NUCLEAR ENERGY INSTITUTE

**SUBJECT:** NEI International Nuclear Event Scale Recommendations July 2003

Nuclear Energy Institute  
International Event Scale Meeting  
June 25, 2003

PWR Typical Technical Specification Activity Example Curve

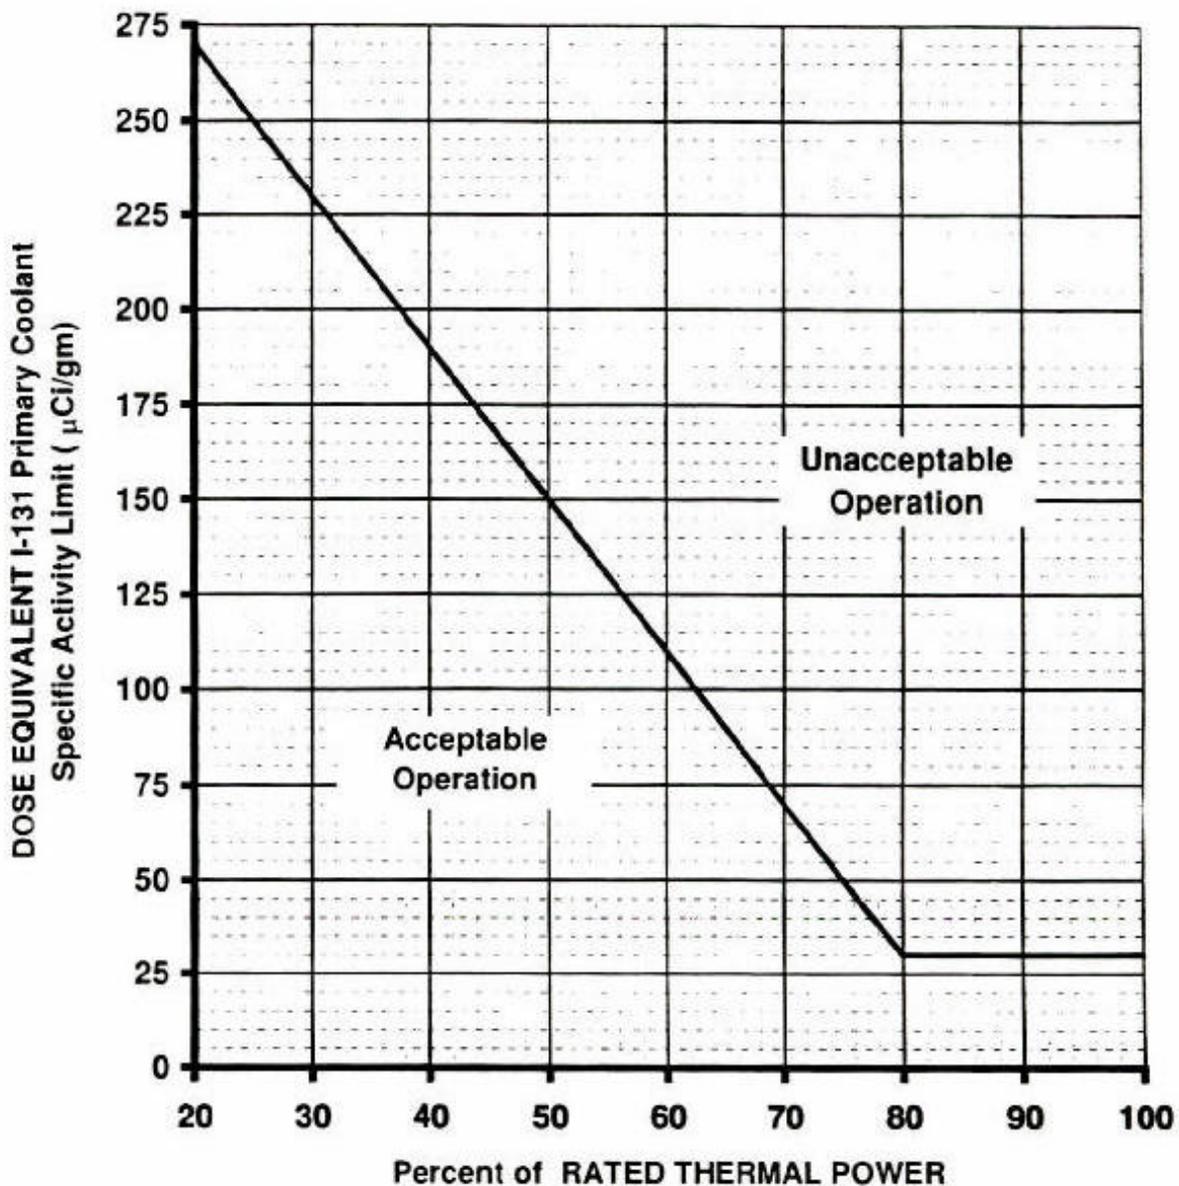
In most US industry events involving fuel clad damage over the last 20 years, RCS activity has remained within the Technical Specification LCO range with I-131 coolant activity remaining in the acceptable operating range of the Technical Specification activity limit curve (an example typical PWR curve is attached). Using a literal interpretation of the INES criteria these events could have been misinterpreted, especially for BWR events, and end up being over-classified using On-Site impact criteria instead of Defense-in-Depth impact criteria. The following supporting details assume that "barrier damage" or "core damage" is synonymous with "clad damage" (i.e.. this is not an overheat/melt condition):

DEI elevated into the Unacceptable Operation region of the Technical Specification transient limit requiring shutdown.

DEI elevated into the Allowable Operation region of the Technical Specification transient limit for greater than the specified action statement time limit requiring shutdown.

DEI elevated out of normal Technical Specification operating limit but returned to within normal operating limit within specified action statement time limit with no shutdown required
